City of Portland Design Commission

Design Advice Request

SUMMARY MEMO

Date: January 7, 2022
To: Dave Otte, Holst Architects
From: Tim Heron, Design / Historic Review Team
(503) 823-7726, tim.heron@portlandoregon.gov
Re: EA 21-105638 DA – Hollywood Transit Center HUB Housing
Design Advice Request Commission Summary Memo – December 16, 2021

PROPOSED SITE PLAN

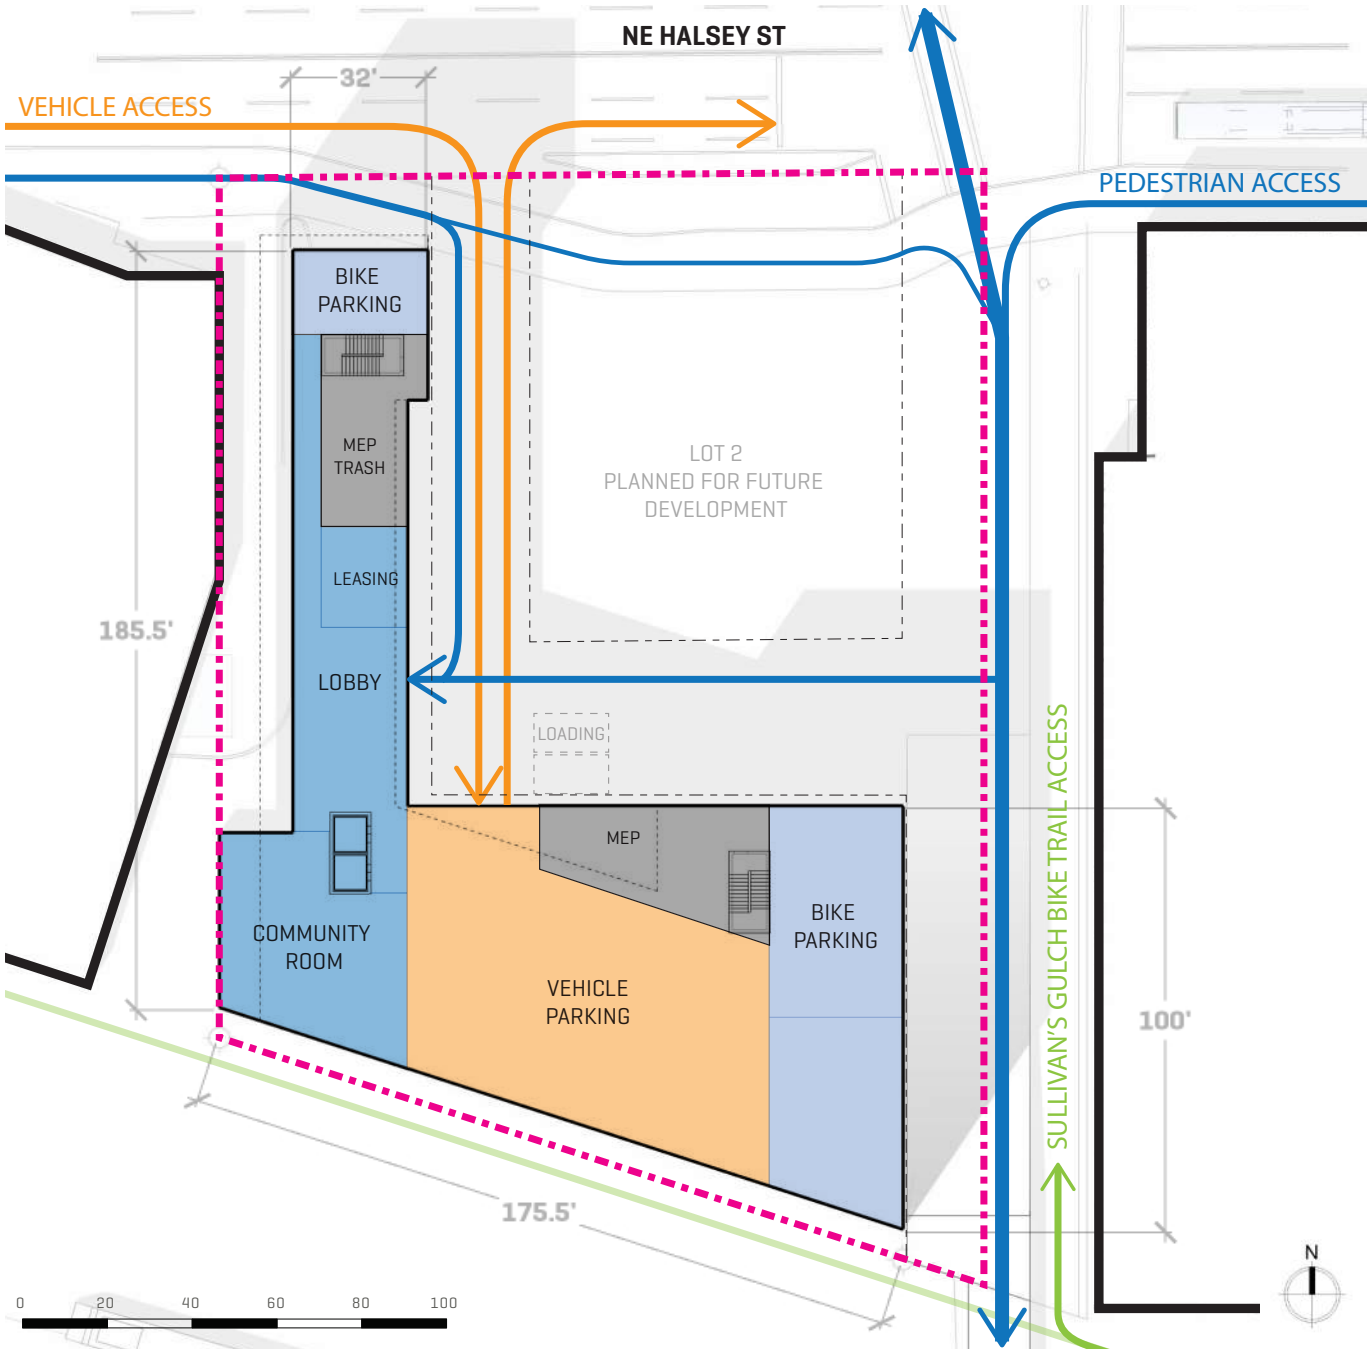
- ***33.130.242 Transit Street Main Entrance, requires max 25’ and face within 45 degrees of NE Halsey to proposed 100’ and not facing Halsey***
- Commission was unanimous with critical concerns that the proposed design, specifically the adjacent inactive ground floor uses, vehicle access, exterior loading, and related Modification requests made this parti extremely flawed. Significant redesign should be considered.

- Commissioners all agreed that vehicle access along the shared driveway to non-required ground floor parking was a critical flaw to the building design, particularly the related Modification requests to the main entrance and pedestrian standards.

REQUIRED OUTDOOR AREA

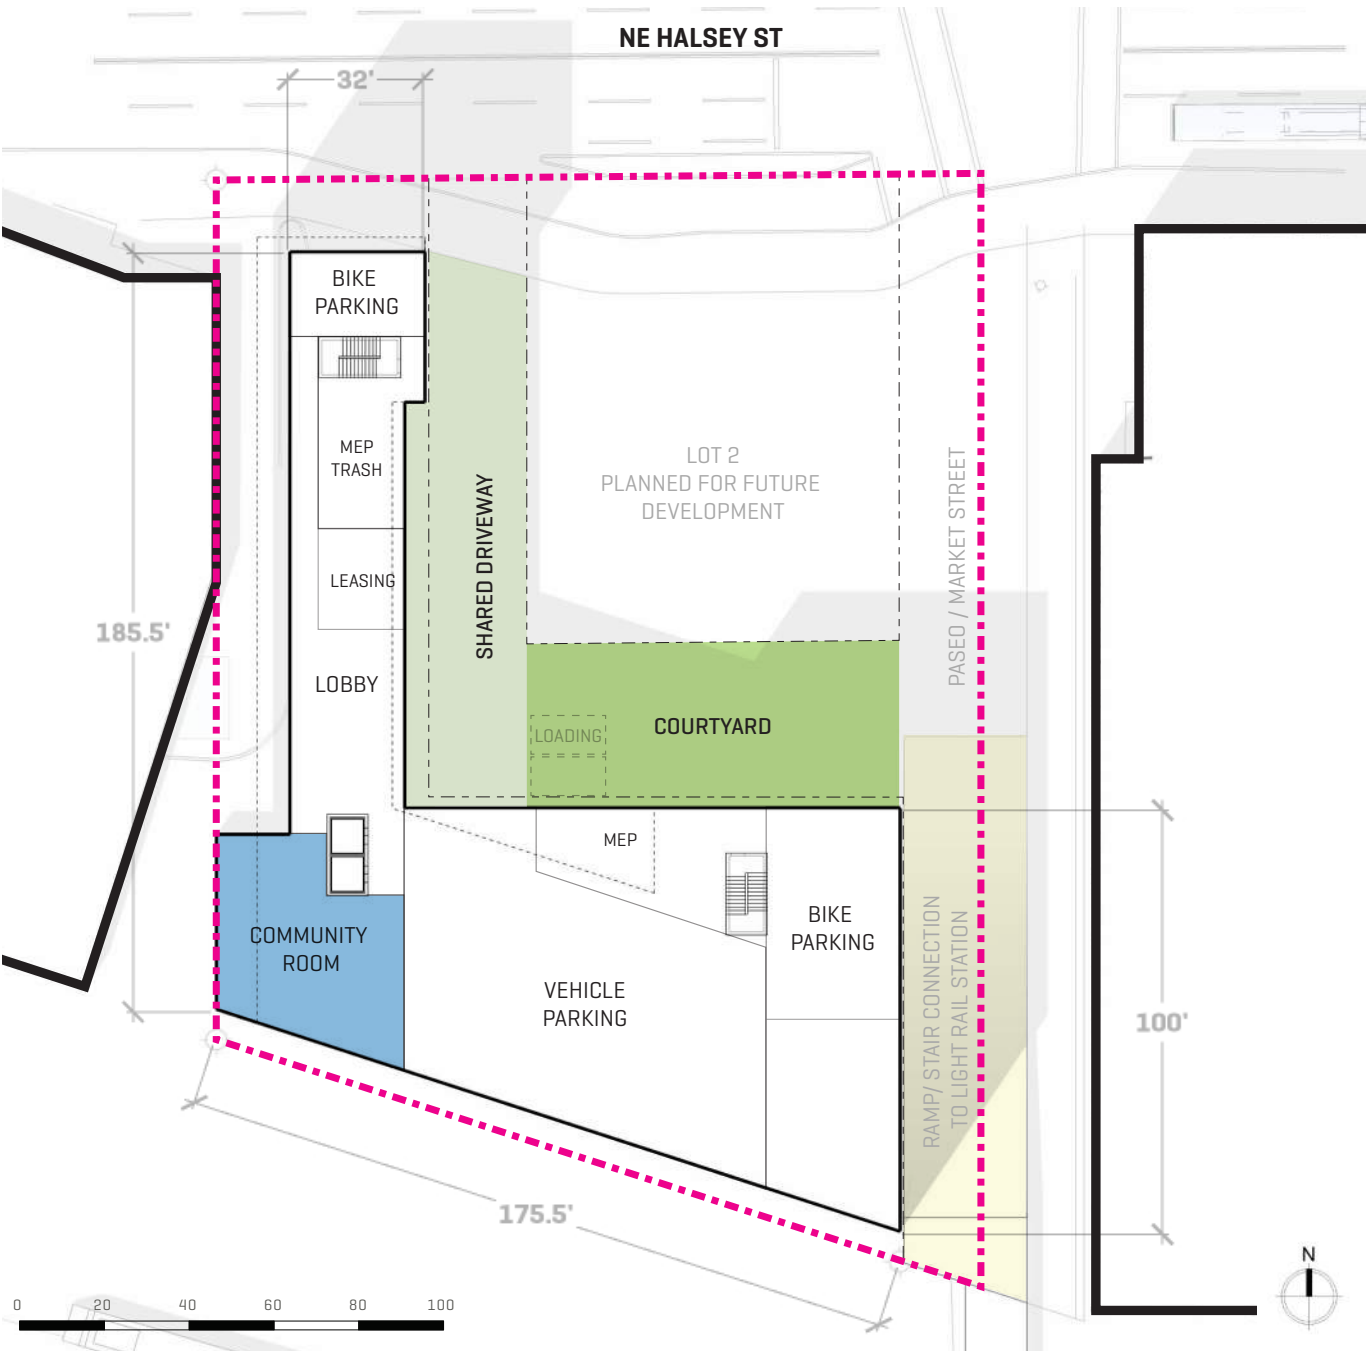
- ***Modification 33.130.228 Required Outdoor Areas, for sites larger than 20,000 SF, 48 SF of outdoor area per unit is required, or 9,648 SF; 8,700 SF proposed***

- The associated Modification request to the Zoning Code did not appear to A - Better meet the applicable Design Guidelines, B - Be consistent with the Purpose Statement of the standard being modified, and C - Provide mitigation for the impact [approval criteria listed in 33.825.040.A-C].

- Commissioners agreed that balconies would improve the residents' outdoor space opportunities, as well as meeting required open area per the Zoning Code, but also add relief and articulation to the massing of the building.
 - Commissioners specifically noted that balconies fronting the interior L-shaped massing proposed would improve the success of these two pedestrian focused ground level conditions.
- Commissioners agreed that open balconies along the south elevation facing Interstate 84 and above the Union Pacific Railroad and would not be a desirable feature.

POTENTIAL MODIFICATIONS

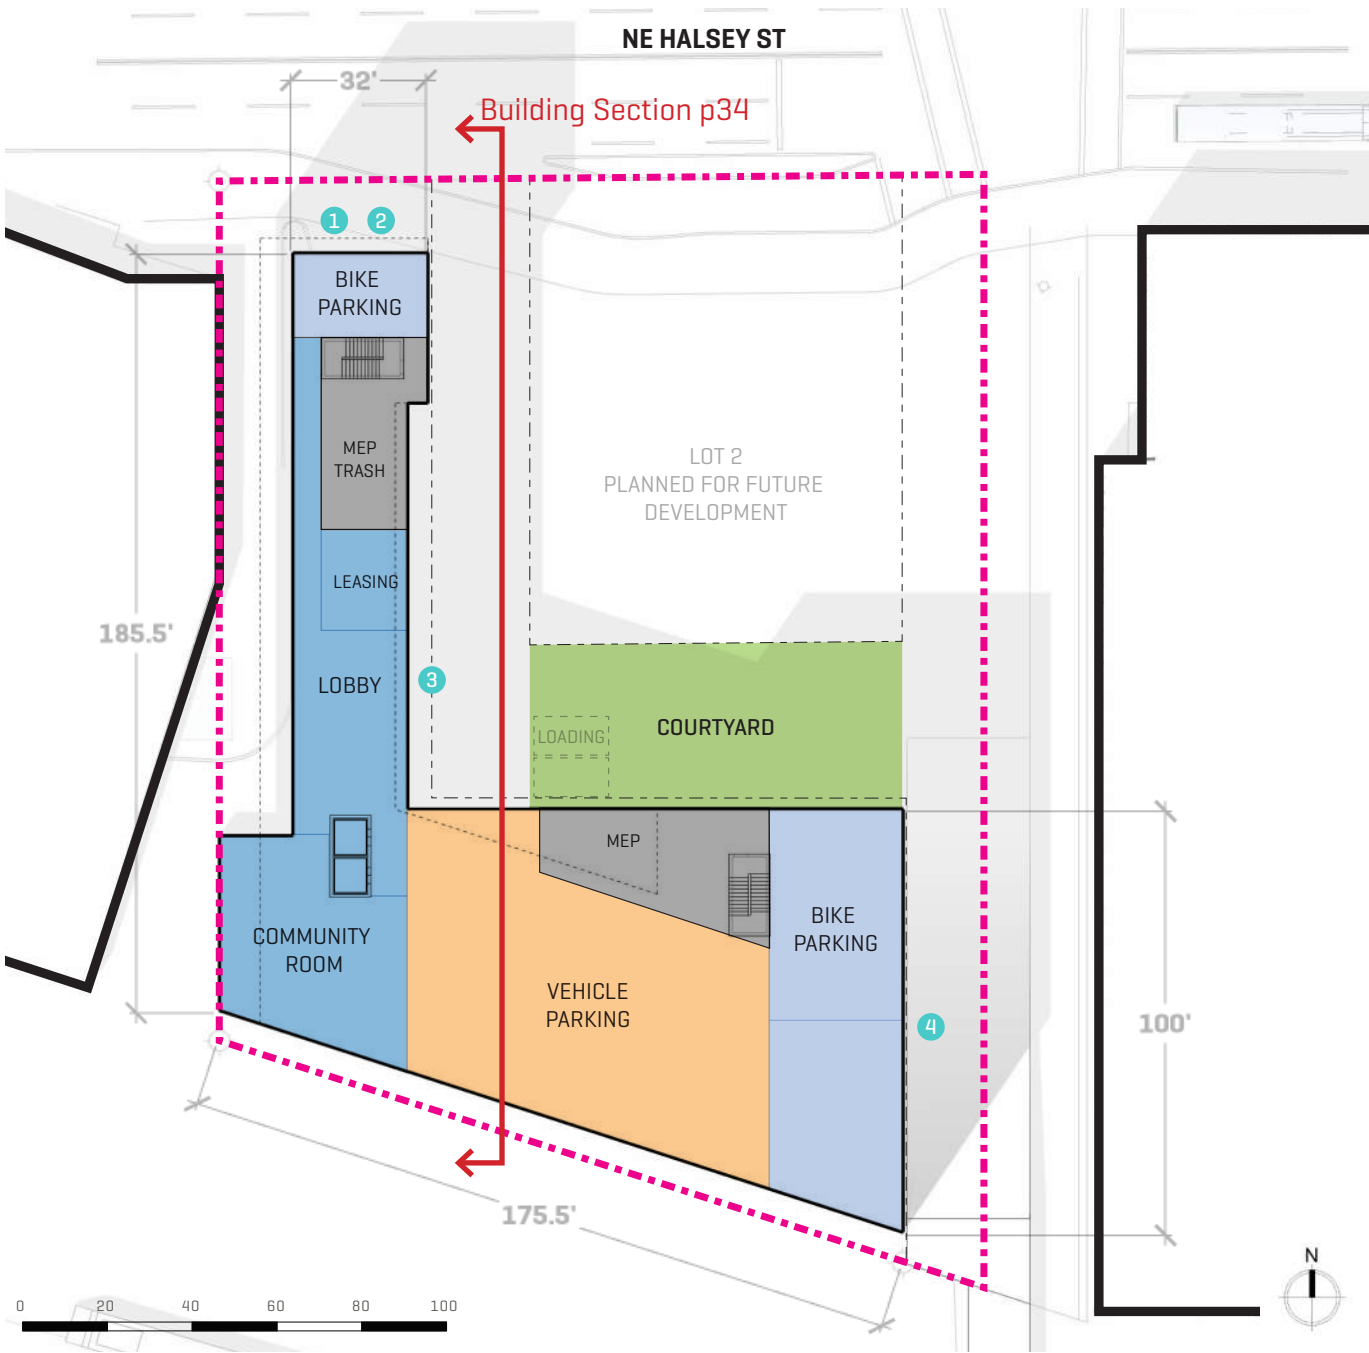
- **In lieu of residential lobby, bike room proposed, triggers Modification**
- **33.130.230.B Ground Floor Windows, required 60%, proposed 15%**
- **33.415.200 Required Ground Floor Active Use, required 25%, proposed 0%**

- The associated Modification requests to the Zoning Code did not appear to A - Better meet the applicable Design Guidelines, B - Be consistent with the Purpose Statement of the standard being modified, and C - Provide mitigation for the impact [approval criteria listed in 33.825.040.A-C].

- One Commissioner noted the plan disregards the requirement for active use on the ground floor. The active use that is shown is located far from the street, so those active uses are not responding, respecting, or improving the public realm.
